STAFF RECOMMENDATION
1004 Lawrence Avenue
June 17, 2020

Application: New Construction—Outbuilding
District: Waverly-Belmont Neighborhood Conservation Zoning Overlay
Council District: 07
Base Zoning: R8
Map and Parcel Number: 10513016300
Applicant: Hunter Conley, Allard Ward Architects
Project Lead: Sean Alexander, sean.alexander@nashville.gov

<p>Description of Project: An application to construct a one-story outbuilding in the rear yard behind an historic house. The outbuilding will meet the required setbacks but will be separated from the house by less than twenty feet (20').</p> <p>Recommendation Summary: Staff recommends approval of the proposed outbuilding at 1004 Lawrence Avenue with the condition that the window and door selections are approved prior to construction. Meeting that condition, Staff finds that the proposal meets the design guidelines for the Waverly-Belmont Neighborhood Conservation Zoning Overlay.</p>	<p>Attachments A: Photographs B: Site Plan C: Elevations</p>
--	--

Figure 2: Portion of site planning showing relationship of outbuilding to the existing

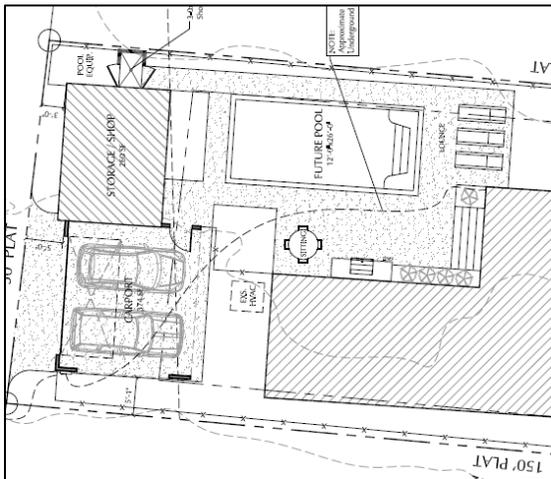
The outbuilding will be separated from the house by only ten feet (10') whereas twenty feet (20') is typically required by the design guidelines. The short separation is the result of the depth of the addition that was constructed prior to the creation of the overlay. In this case, because the addition does not extend the full-width of the house, only half of the outbuilding has less of separation than typically required.

In addition, both the addition and the outbuilding are one-story, lessening the visual impact. The administratively issued ridge raise does not impact the wing of the addition that is behind the left half of the building, which will remain one-story.

For this reason, Staff finds that the location and setbacks for the proposed outbuilding are appropriate and meets section III.H.6 of the design guidelines for outbuildings.

Site Layout Plan

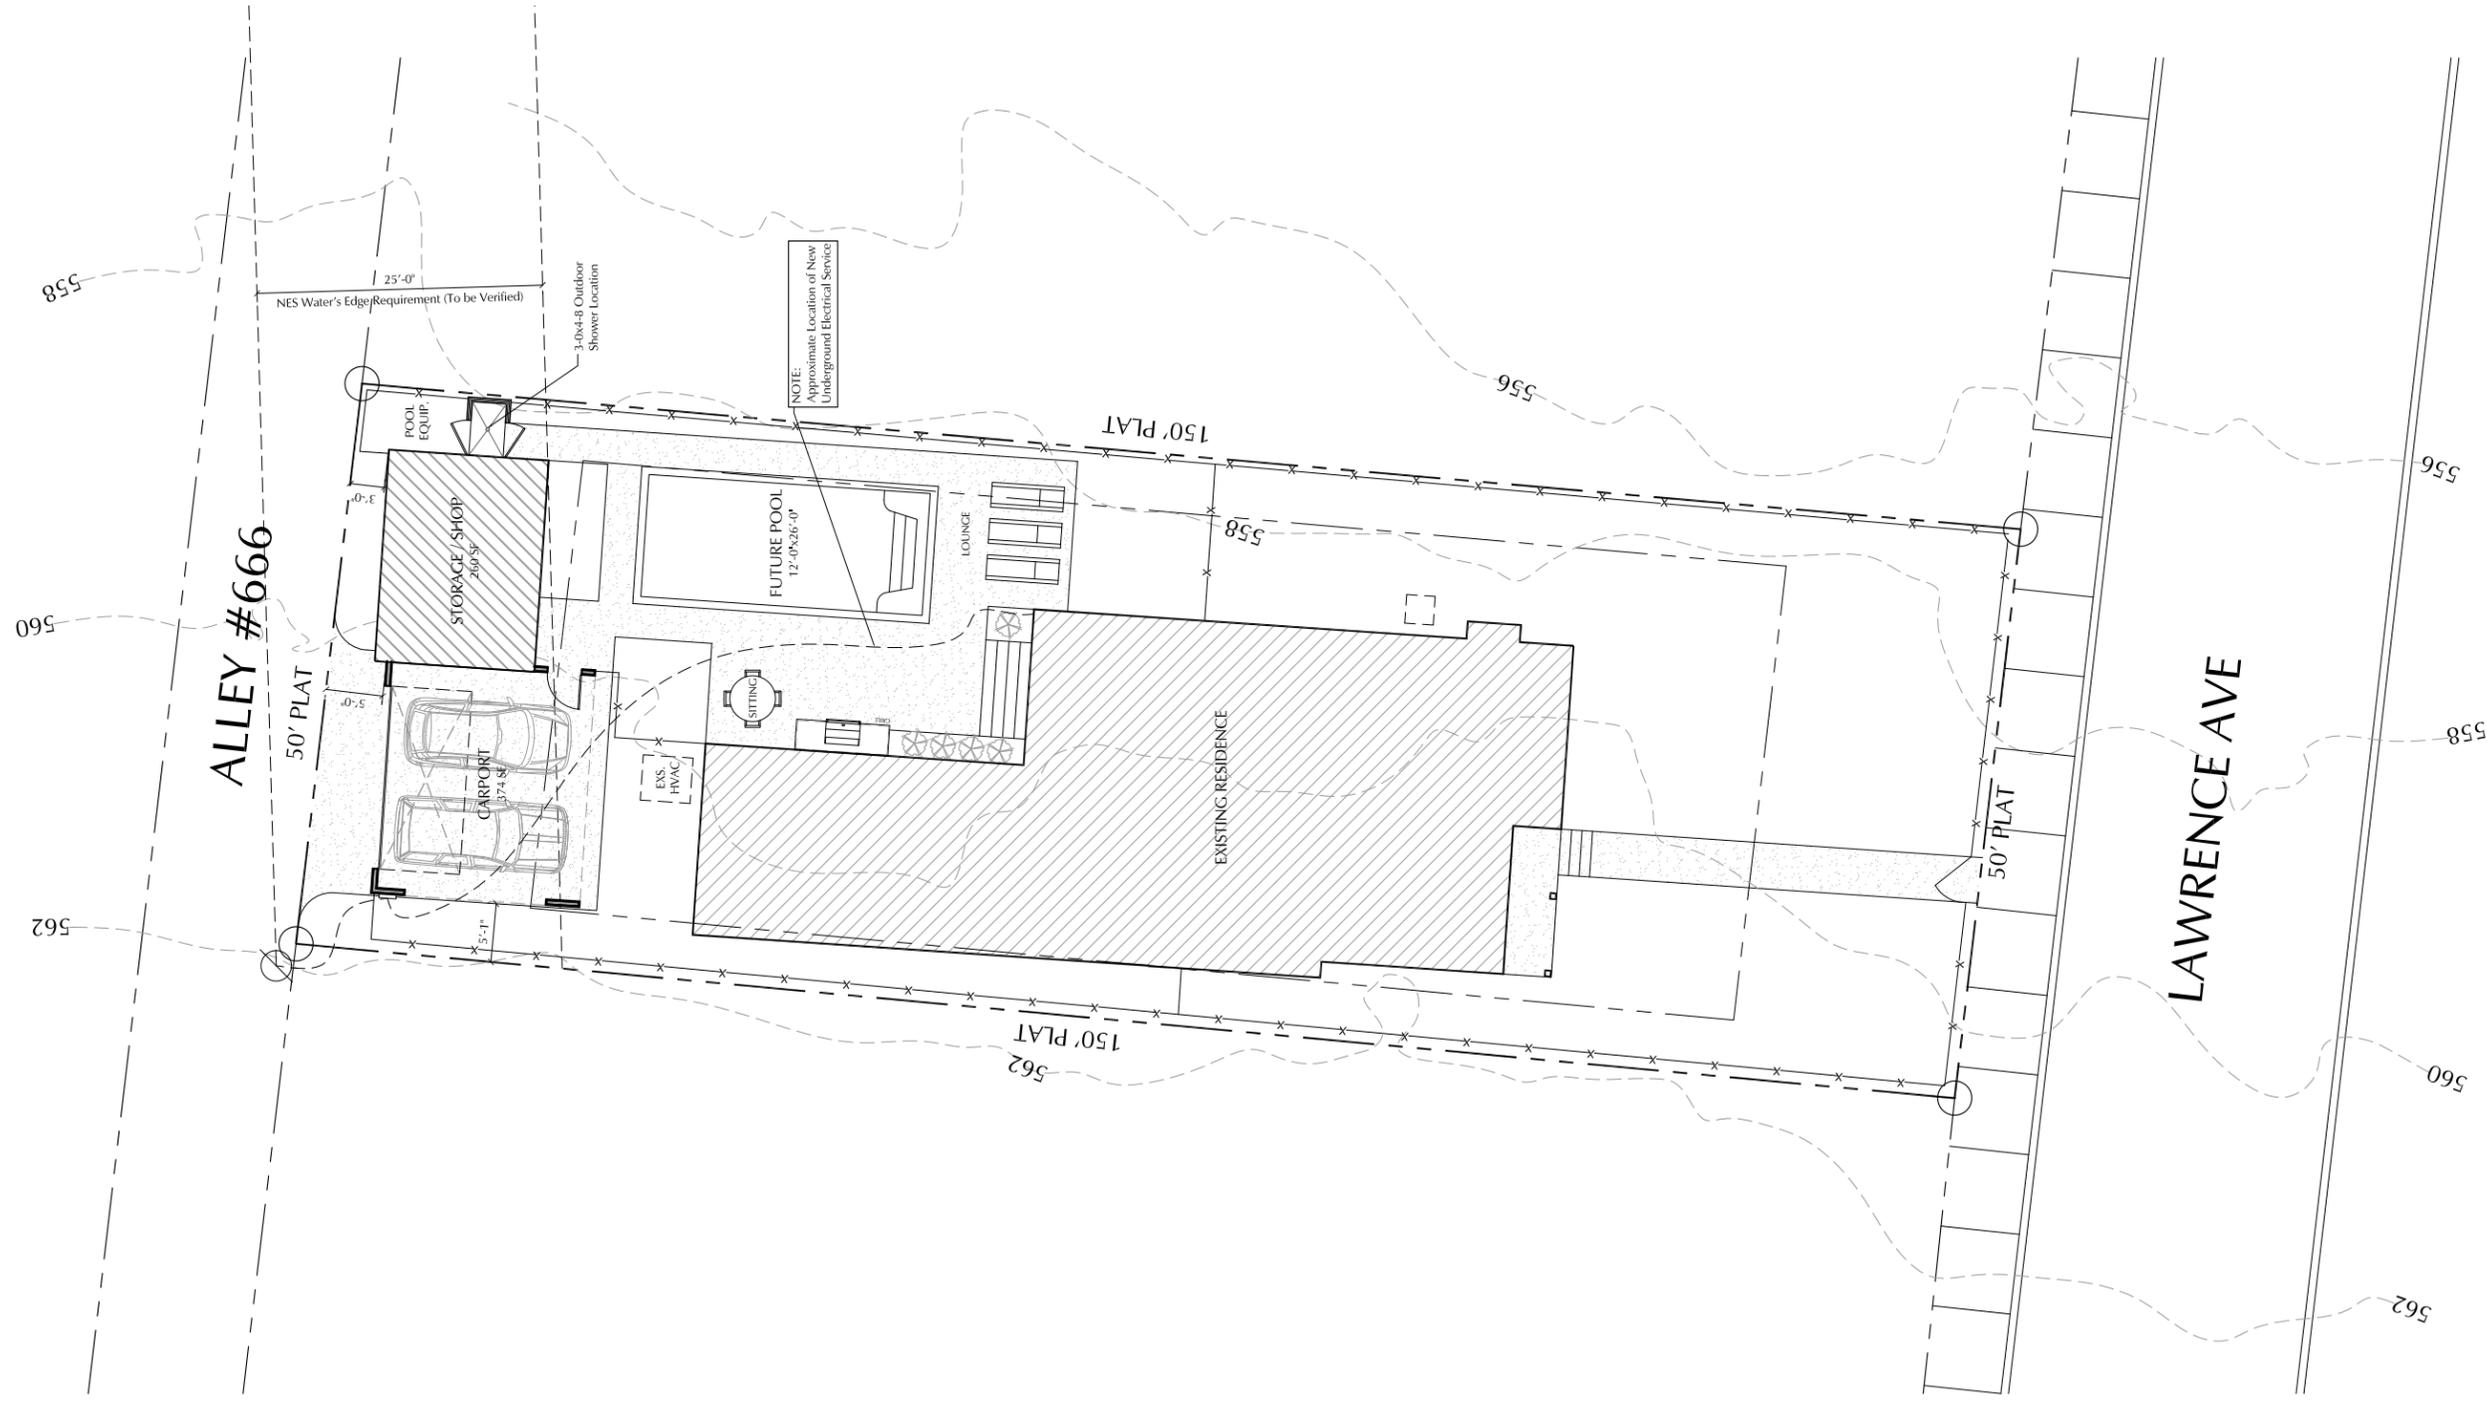
MINIMUM	PROPOSED
Building located towards rear of lot	-	Yes
Space between principal building and garage	20'	10'
Rear setback	3' (5' setback for garage doors)	3' (5' setback for garage doors)
Left side setback	3'	5'
Right side setback	3'	5'
How is the building accessed?	-	From Alley at Rear

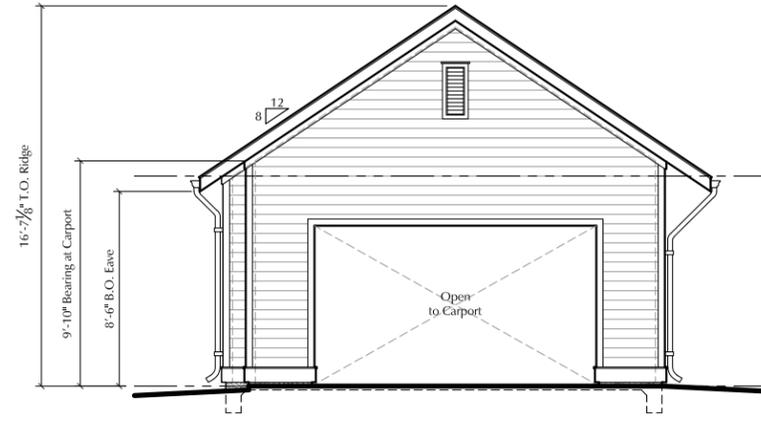
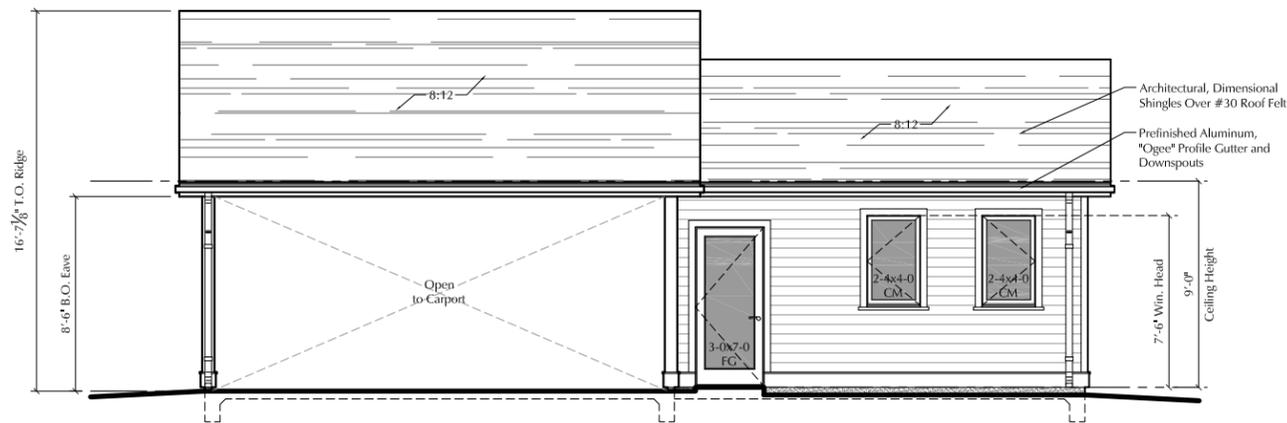
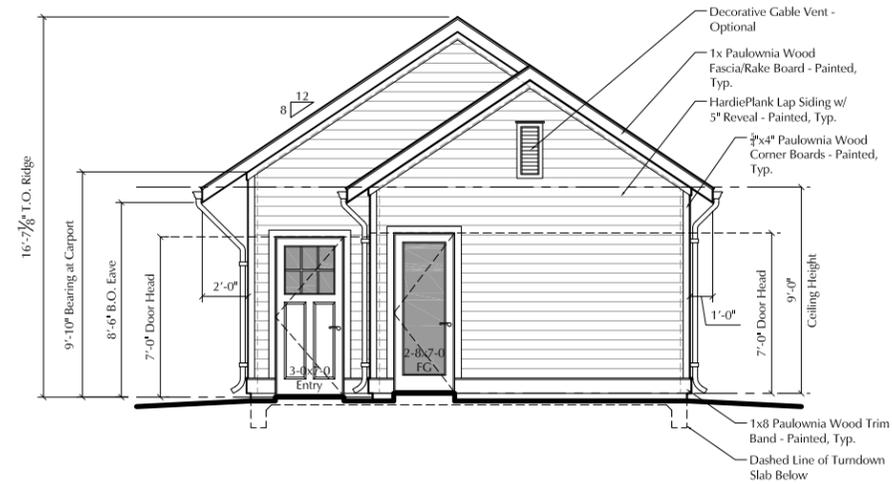
Potential 1-Story or 1.5-Story Outbuilding	Proposed Outbuilding
Ridge Height	25' (not to exceed principal building height)	16'-7"
Eave Height	10'	9'

The footprint of the new outbuilding will be below maximum permitted by the design guidelines for the size of the lot. The roof and eave heights are compatible with the corresponding heights of the house and are less than the maximums allowed by the design guidelines. Staff finds that the application meets Section III.H.1. of the design guidelines for height and scale.

The proposed roof form has a side-gabled roof, which is compatible with the roof on the historic house. Staff finds that the application meets Section III.H.3 of the design guidelines for roof form.

The known materials for the outbuilding meet section III.H.5. of the design guidelines. Staff recommends that the window and door selections shall be approved by MHZC staff prior to construction.

Recommendation: Staff recommends approval of the proposed outbuilding at 1004 Lawrence Avenue with the condition that the window and door selections are approved prior to construction. Meeting that condition, Staff finds that the proposal meets the design guidelines for the Waverly-Belmont Neighborhood Conservation Zoning Overlay.
